1. Can the applicant please provide the chemical analysis test result for imported soil materials brought to the site in February 2025?

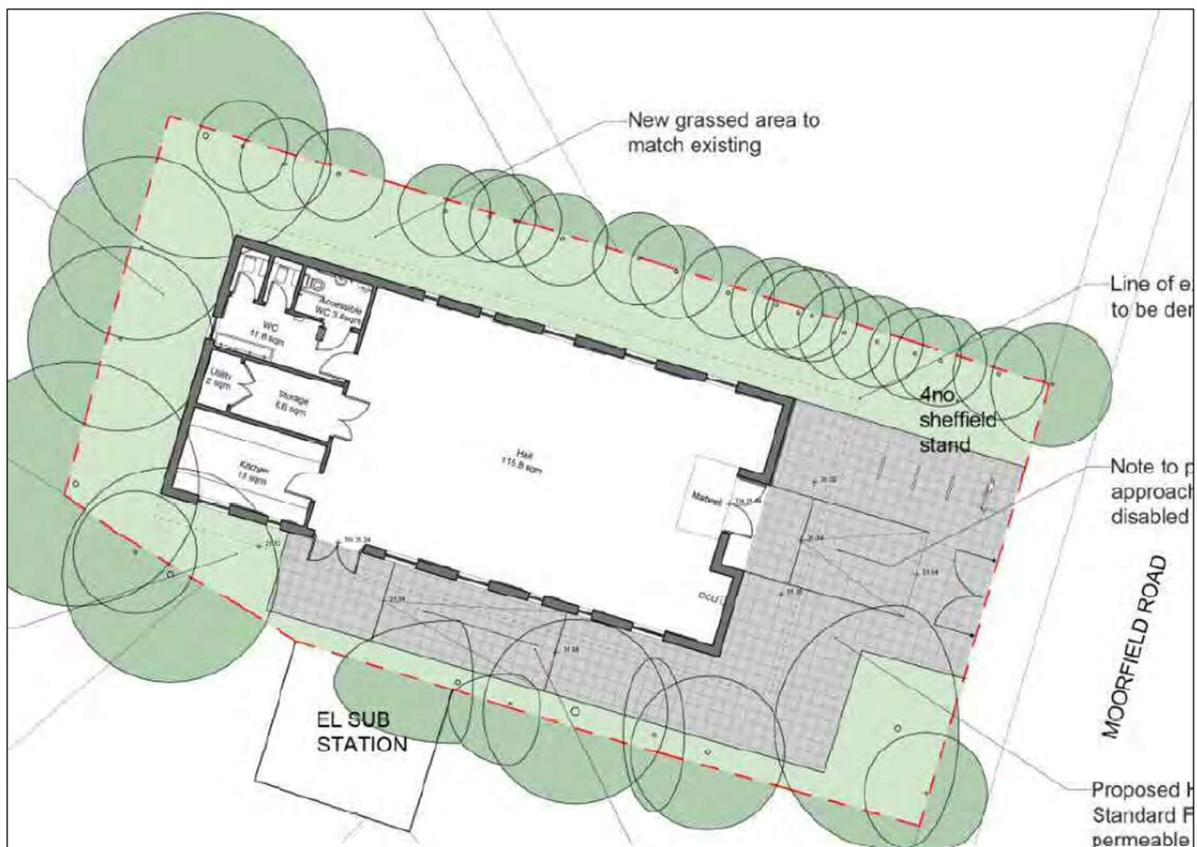
2. Whilst the proposed applicant remedial strategy of providing a combination of hardstanding and a simple cover system to areas of soft landscaping is noted, we have no evidence of excessive trees on site to prevent the installation of the agreed 460mm clean cover system on the site.

The following drawings which were appended to the latest Verification Statement, make it clear that the majority of the site is either subject to provision of hard landscaping (blue hashed areas on the left hand drawing and grey areas on the right hand drawing) or within root protection zones (pink dashed circles). For clarity, the only area of soft landscaping, which is not restricted by the root protection zones, or by provision of hard landscaping (which mitigates the requirement for a simple cover system) is highlighted

in green below. Alternatively, we would welcome a site visit to help in providing a better understanding of the site layout and restrictions.
